REV.
C

AS3086™

AEROSPACE STANDARD

STUD - STRAIGHT, KEY LOCKED,
CADMIUM PLATED, STEEL, UNS G87400
.1900-32 UNJF-3A X .1900-32 UNJF-3A

FIGURE 1 - STUD

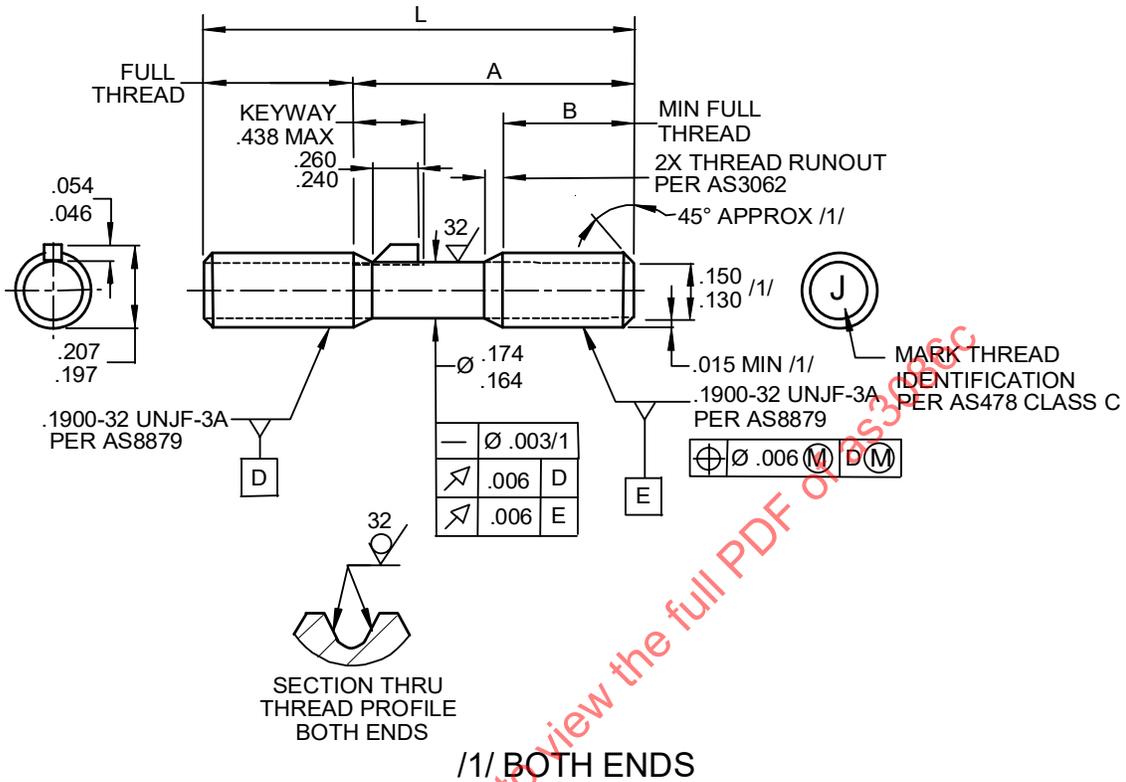
FIGURE 1 REDRAWN TO ASME Y14-2018, USAGE NOTE ADDED, SPECS UPDATED, THREAD END CHAMFERS ALTERED TO AS1132 STANDARD.
